Urban Design Committee  
Staff Report  
5331-3 Roose St./Neighborhood Design Standards  
Agenda of August 4, 2015

Dick Robison has applied for a building permit for a building at 5331 Roose Street, to contain a pair of townhouse. Roose is on the north side of the Antelope Creek channel west of 56<sup>th</sup> Street. The Billy Wolfe Trail is south of the channel and Van Dorn Street is immediately south of the Trail.

"Roose Place" development, built in 2014

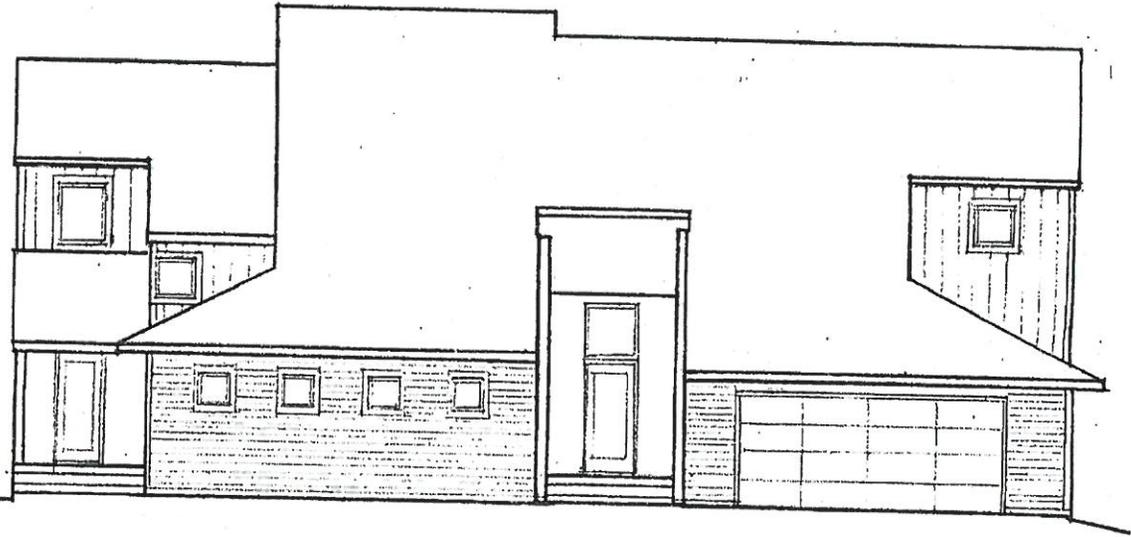
Last year's "Roose Place" construction features a long, linear site along the creek and the pair of houses face north, with north-facing garages at the center of the design.

The façade garages are not a feature of a majority of Roose St. homes, but in this location they were evaluated as not having direct impact on that streetscape. Therefore the Roose Place houses were found to be consistent with the Neighborhood Design Standards.

Site Plan for 5331-3 Roose

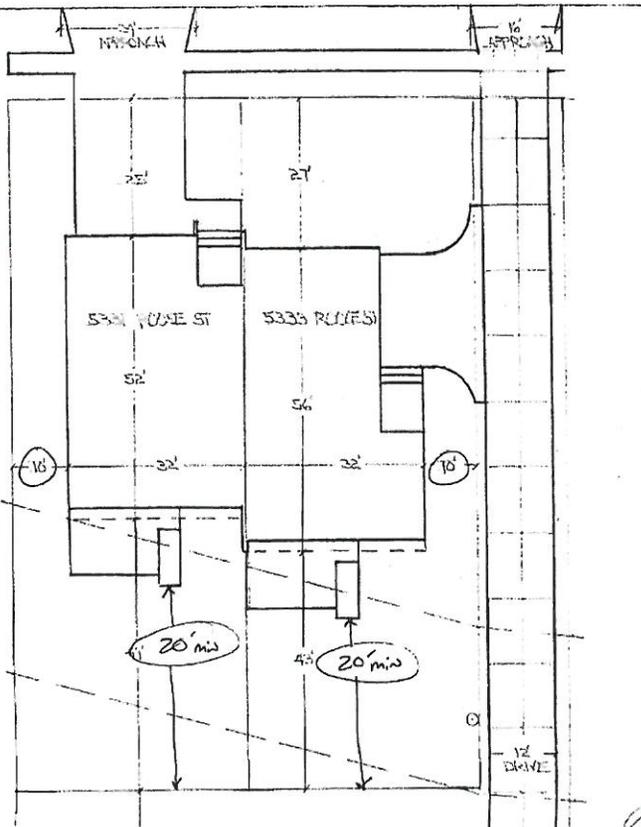
The current proposal for two more townhouses directly on Roose has been directed to the Urban Design Committee because it would be located directly on Roose St. and also proposes a façade garage door for one of the units. The Neighborhood Design Standards call for façade garage doors to be located at least 5 feet recessed when there is no prevalent pattern in a setting (same and facing blockfaces).

The proposed design serves only the west unit's garage directly from Roose, while the east unit's garage would face east and be accessed off the Roose Place entrance drive.

The proposed design is strongly related to the existing Roose Place homes, although adapted to a very different lot. (The diagonal dotted lines on the site plan depict an easement that further constrains the buildable area.) The Roose Place houses are attractive in appearance and establish some context for the proposed construction, within the diversity of house types along Roose Street.

Staff recommend that within the diverse house types of this setting, allowing the proposed design adds to rather than detracts from the context. It proposes an innovative design for a challenging infill site. We recommend that it can be approved by Urban Design Committee as meeting the intent of the Neighborhood Design Standards.
